A REPLAT OF PART OF ECK 7TH ADDITION
SEDGWICK COUNTY, KANSAS

RE: SUB 2003-97 -- One-Step Final Plat of A Replat of Part of Eck Seventh Addition

RE: SUB 2003-97 -- One-Step Final Plat of A Replat of Part of Eck Seventh Addition

CASE NUMBER: SUB 2003-97 -- A REPLAT OF PART OF ECK SEVENTH ADDITION

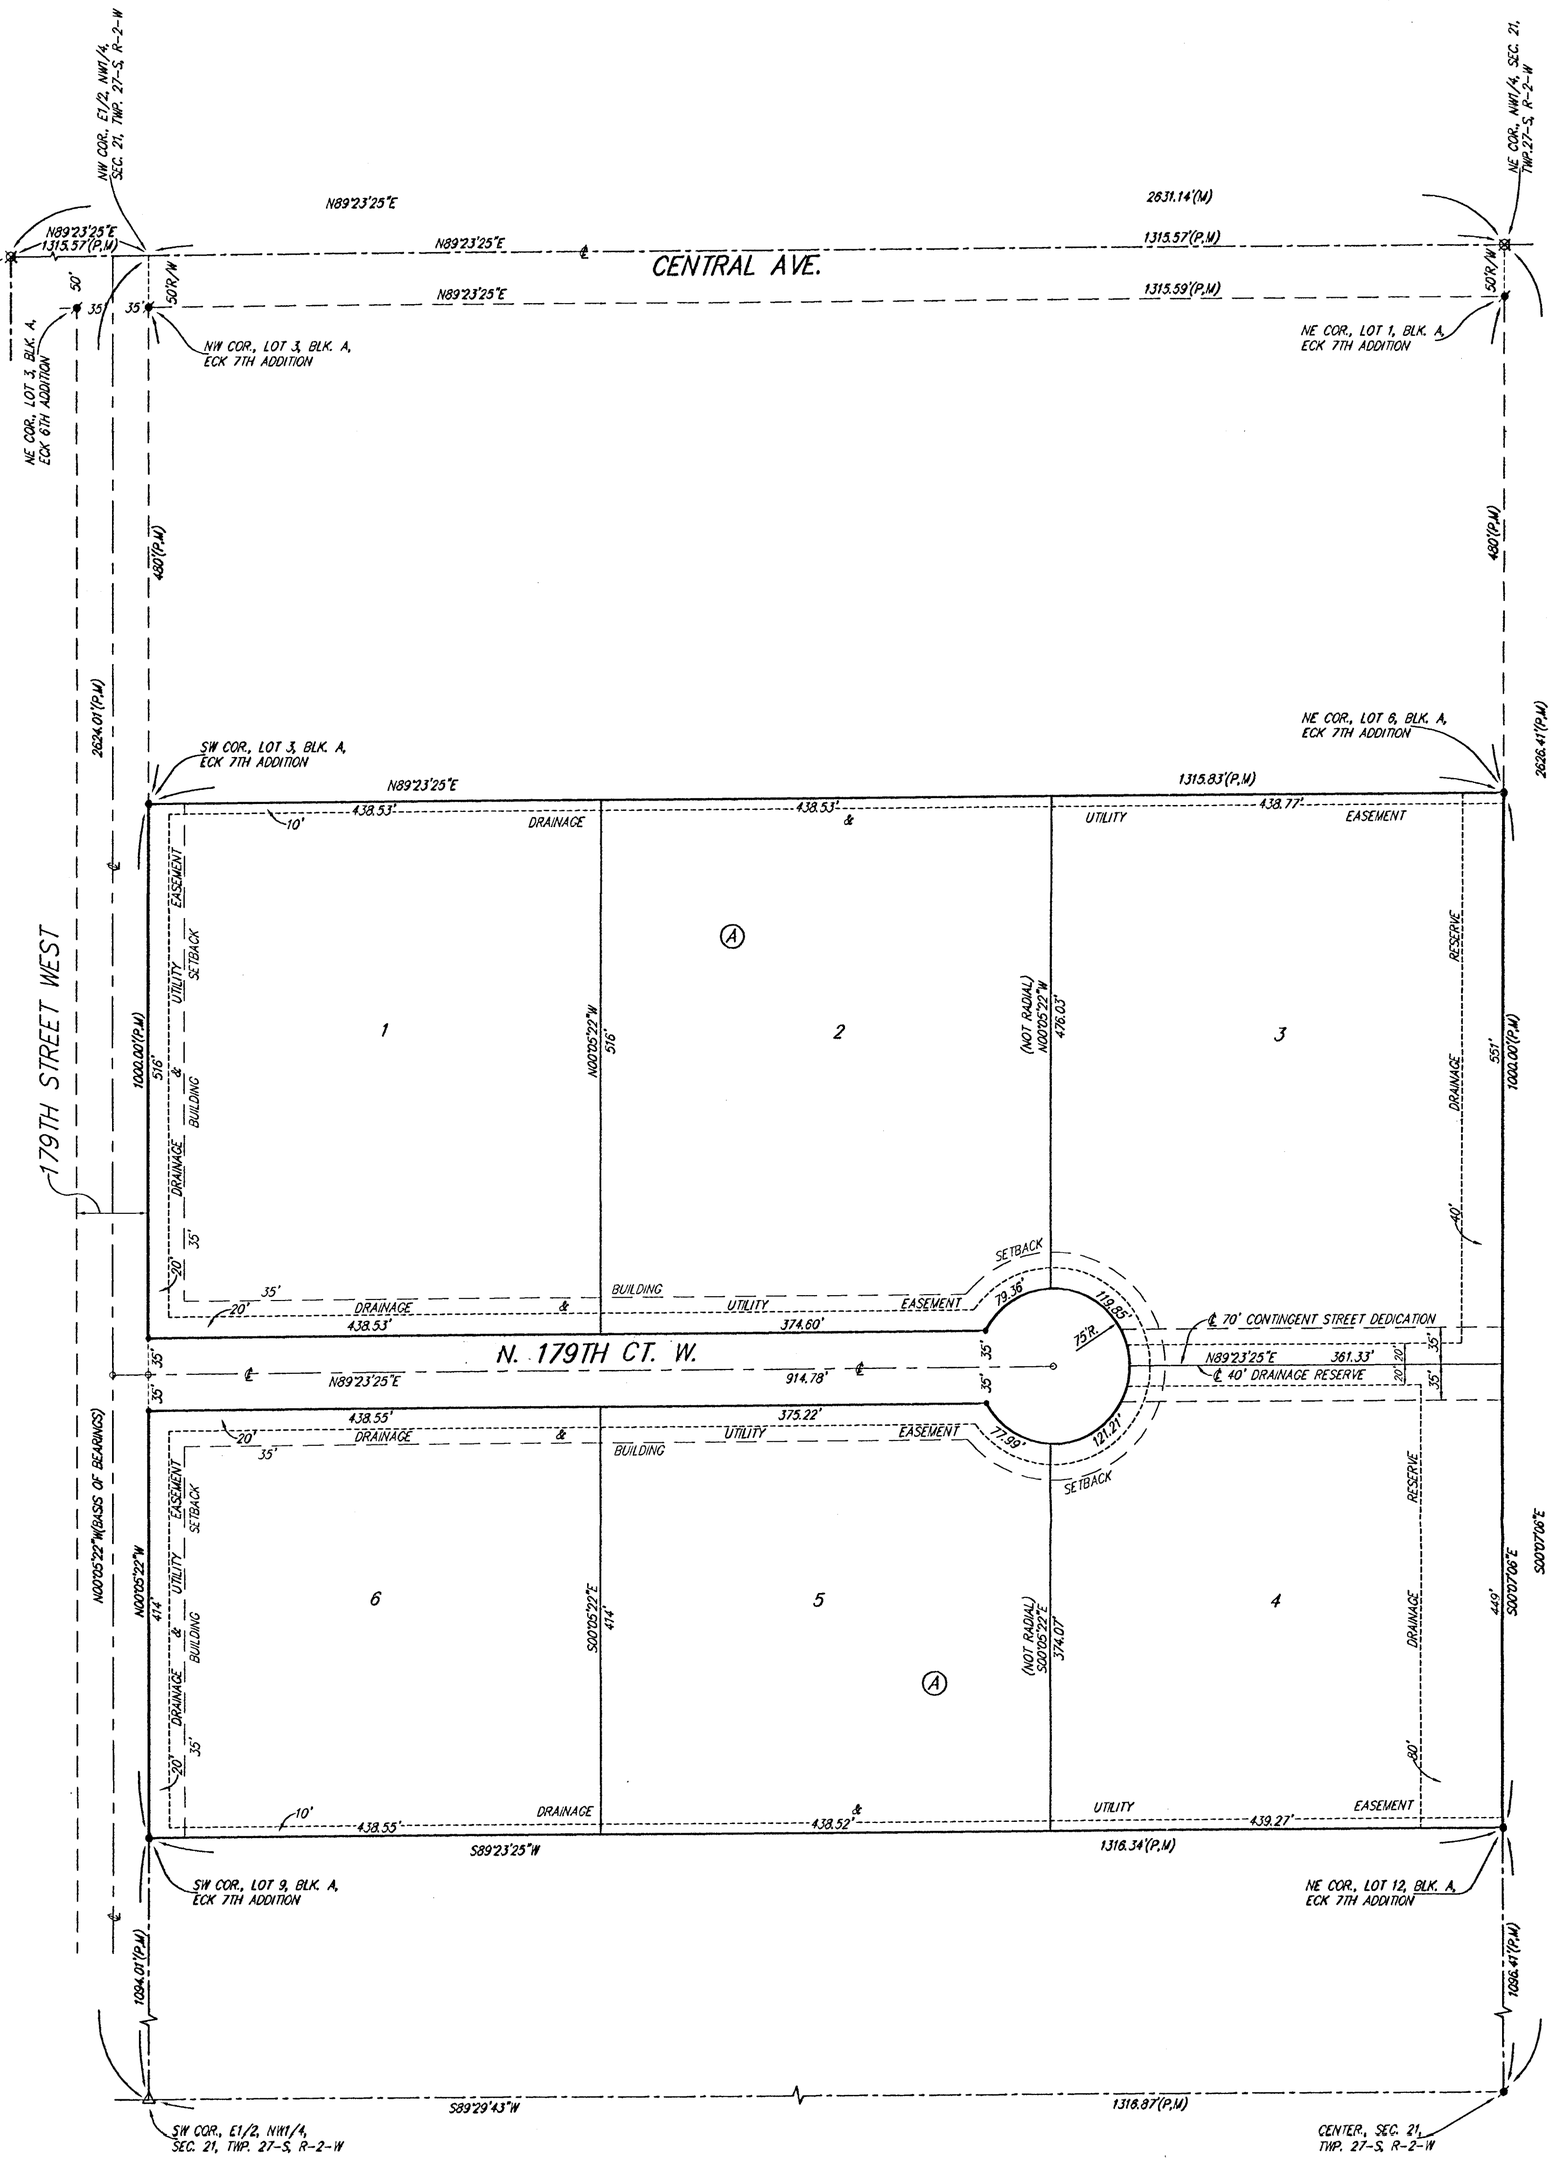
At the regular meeting of the Subdivision Committee of the Metropolitan Area Planning Commission on Thursday, September 11, 2003, the above captioned plat was considered. The action of the Committee was to approve the final plat, subject to the following staff comments:

E. County Engineering needs to comment on the status of the applicant's drainage plan. *A revised drainage plan is needed reflecting new lot layouts.*

G. Lots 4, 5 and 6 contain less than the minimum 4.5 acres needed for lots served by sewage lagoons. A modification will need to be approved by the Planning Commission. A zoning adjustment will also need to be approved by MAPD. *A modification has been approved.*

I. GIS needs to comment on the plat's street names. ***The street name needs to be revised to "N 179th Ct W".***

K. The signature line for the City Clerk needs to be revised to reference "Karen Schofield".

L. The MAPC signature block needs to reference "Ronald L. Marnell, Chair".

M. The plattor's text shall include language that a drainage plan has been developed for the plat and that all drainage easements, rights-of-way, or reserves shall remain at established grades or as modified with the approval of the applicable City or County Engineer, and unobstructed to allow for the conveyance of stormwater.
